Greens Creek Mine

Tailings Disposal Facility Expansion

Final Environmental Impact Statement Appendices

Appendix A, Part 1
Forest Service
Responses to Comments

CROSS SECTION OF PROPOSED ROAD B

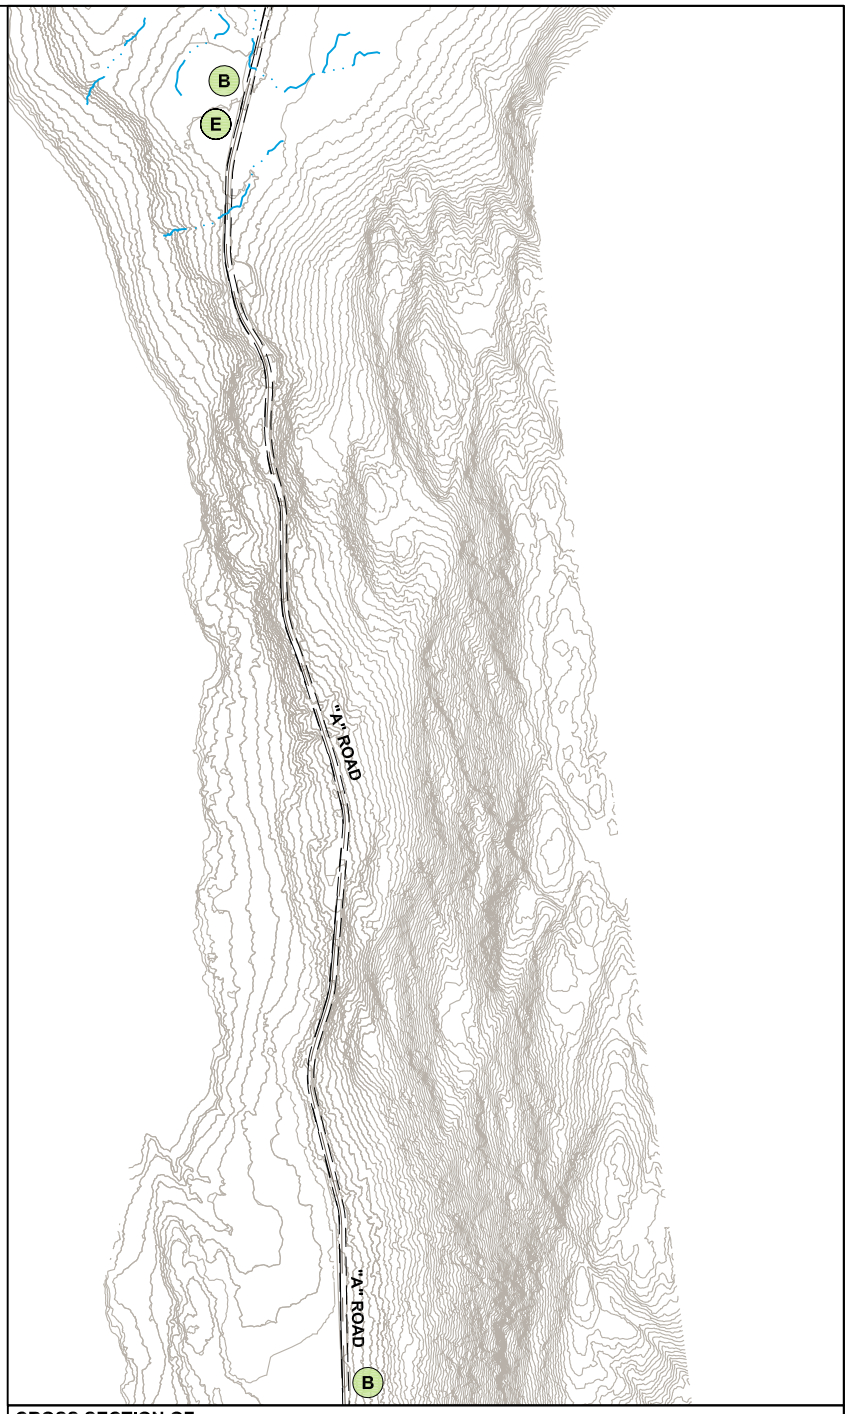
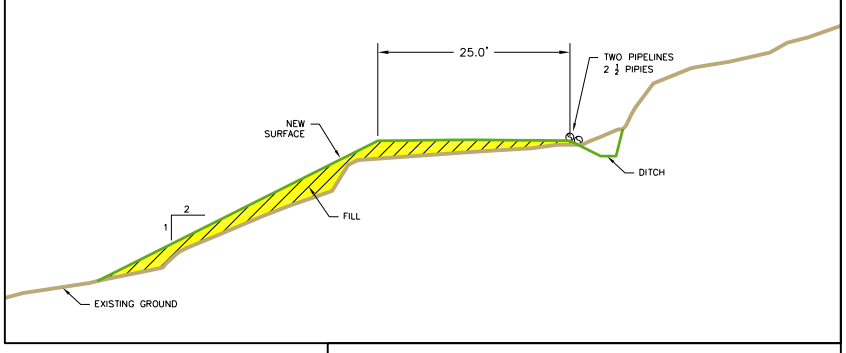
Section 2.3.3, p. 2-10, Figure 2.3-3b, and Section 2.3.4, p. 2-14, Figure 2.3-4b.

JS.5.052 It is difficult to read the inset figure for the cross section of the road. For example, what is the proposed size of the pipelines under Alternatives C and D? Please include additional details regarding the infrastructure required for water management under Alternatives C and D, which may include adding a new figure under Alternatives C and D to expand the cross-section inset that is currently undecipherable in Figures 2.3-3b and 2.3-4b.

Comment ID: JS.5.052
Figures 2.3-3b and 2.3-4b have been updated; the cross-section inset has been enlarged for easier viewing.
